SYSTEM/MODEL: LEF

MODIFICATION: Installing a volume control on an LE series sub station

VOLUME CONTROL ON A SUB STATION

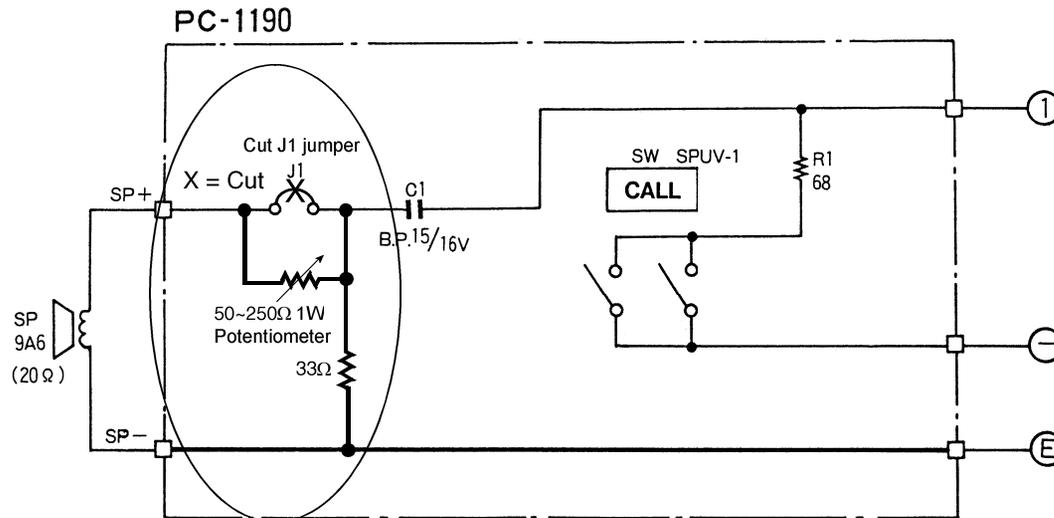
INSTR/OPERATIONS: 1. Install components as shown on the diagram.
2. No physical provisions are made on the sub station for the addition of a volume control. Chassis modification is required.

Add components as shown.
Volume control will affect communication and call tone volume.
